SUBJECT: **Permit Modification Request for TIP No. R-2809B**, Wake County, NC  
DOT Division 5, Federal Aid No. STP-98(1), State Project No. 8.1402501,  
USACE Action ID 199601836, and DWQ Project No. 010550, \$475 Debit  
Work Order WBS Element 34503.1.1

Subject: **Revised Mitigation Request**, Wake Forest Bypass, Wake County, Federal Project No. STP-98(1), State Project No. 81402501, TIP No. R-2809B.

PROJECT: 8.1402501 (R-2809B)  
NC 98 WAKE FOREST BYPASS

**PLAN VIEW  
SITE 4**

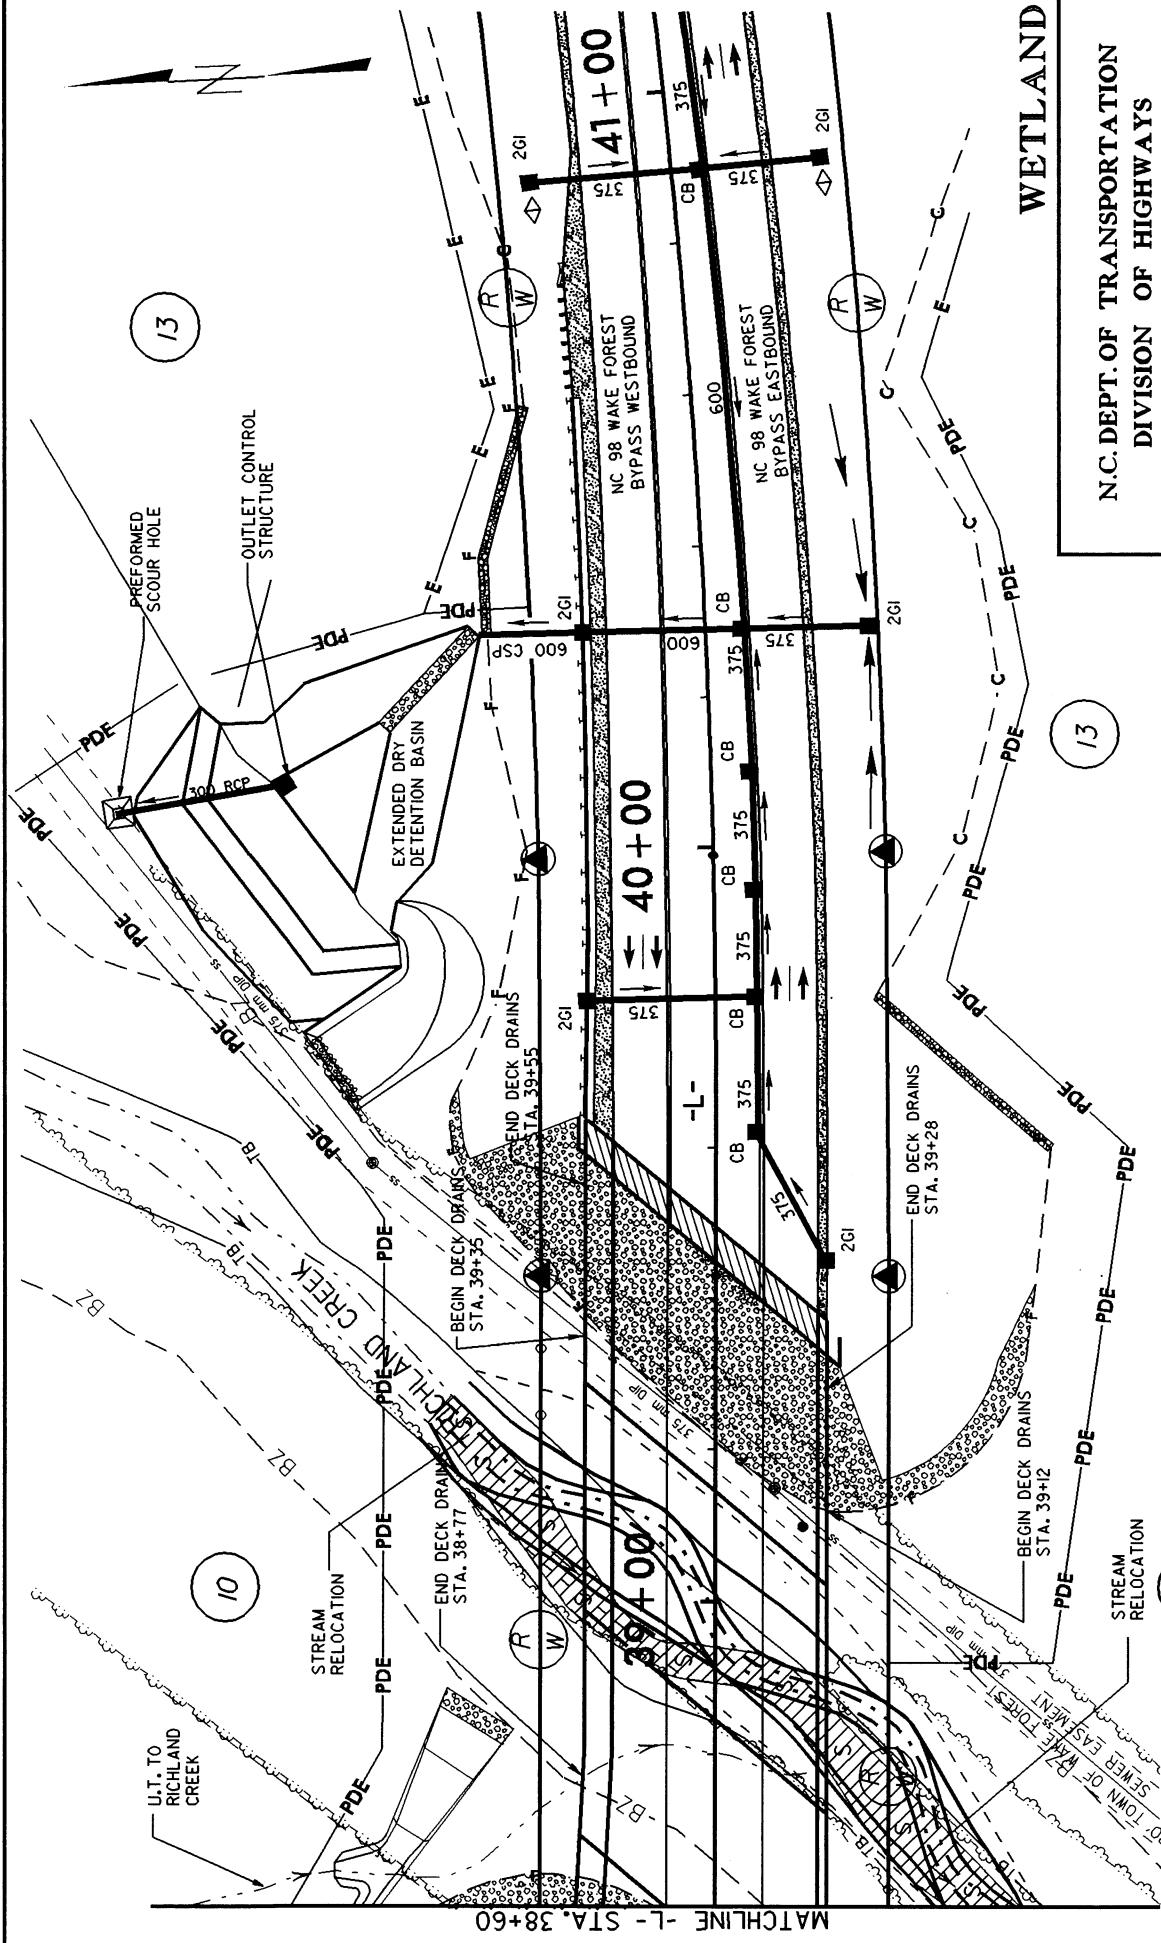
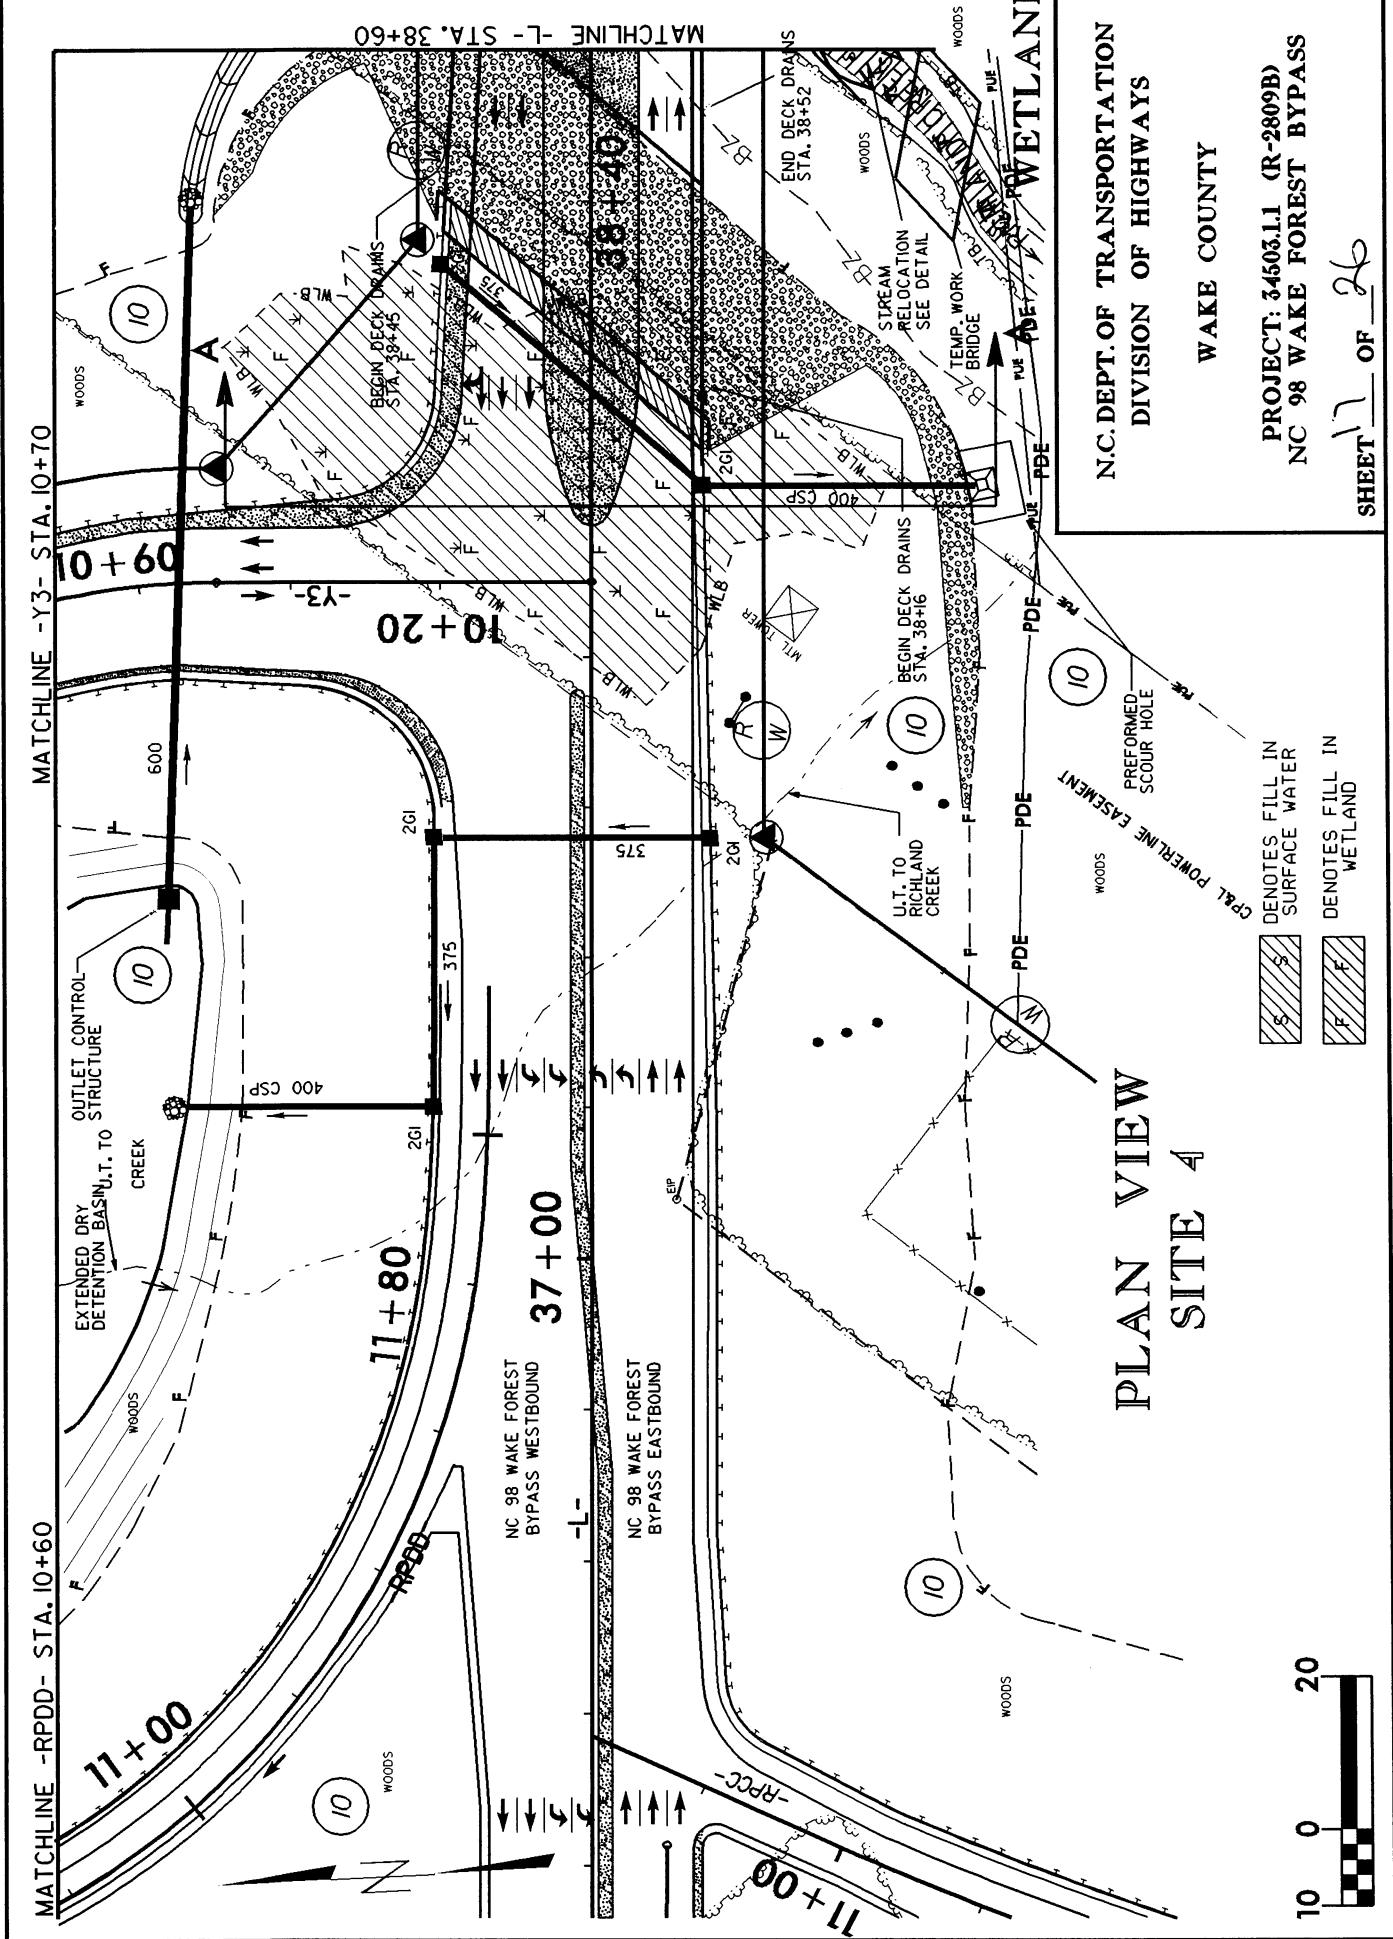
Site 4, Sheets 17 and 18 of 26

Station -L-38+84

The original survey of Richland Creek was inaccurate and did not take into account a bend to the west. The project was originally designed so that all bents would not be placed in Richland Creek. However, due to the inaccuracy of the survey, piers 1 and 2 of the bent 2 would fall in the stream. An onsite field meeting was held on June 17 between NCDOT officials, USACE and NCDWQ. During the meeting it was agreed that the banks of Richland Creek were not stable and that Richland Creek could be relocated using natural stream design. Approximately 351 feet of Richland Creek will be relocated. Due to the limited amount of space between the bents and an existing below ground sewer line the relocation of Richland Creek will require two phases of temporary diversion channels. The sequencing of the stream relocation is as follows:

**Impact change: increase of 351 ft of permanent Stream Impacts**

**Increase of 351 ft of Natural Stream Design**

Increase of 82 feet of temporary Stream Impacts

## PLAN VIEW SITE 5

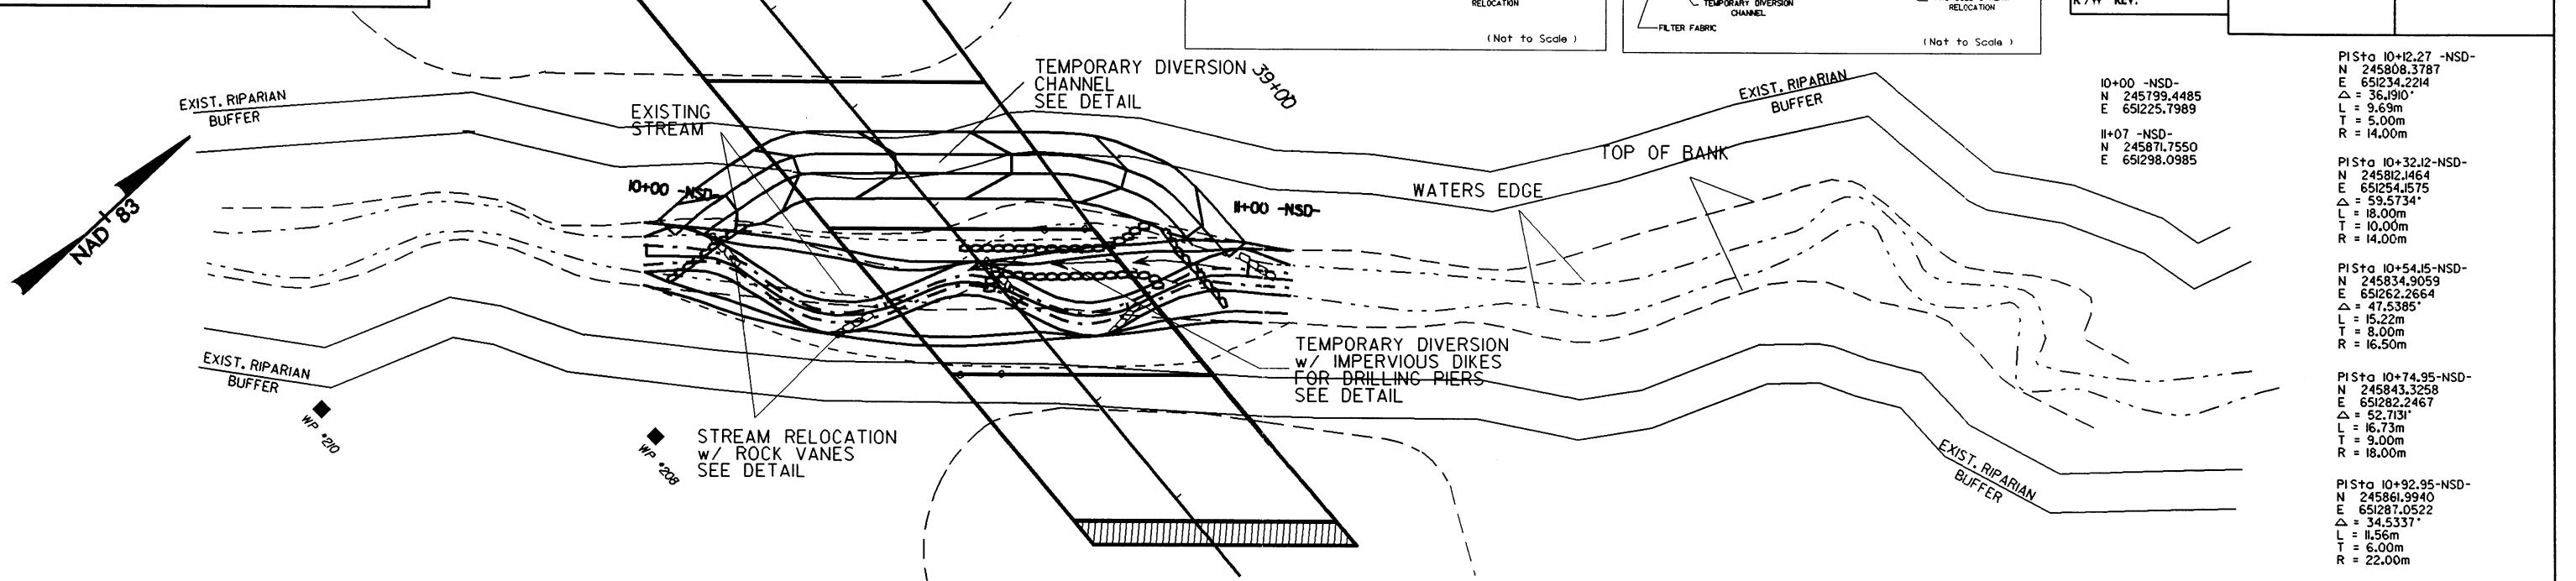
Site 5, Sheet 21 of 26

Station -L-47+09L / 47+70R

The entire temporary drainage easement will be required to allow equipment access so that the contractor has sufficient room to install the culvert.

**Impact change: increase of 61 ft of temporary Stream Impacts**
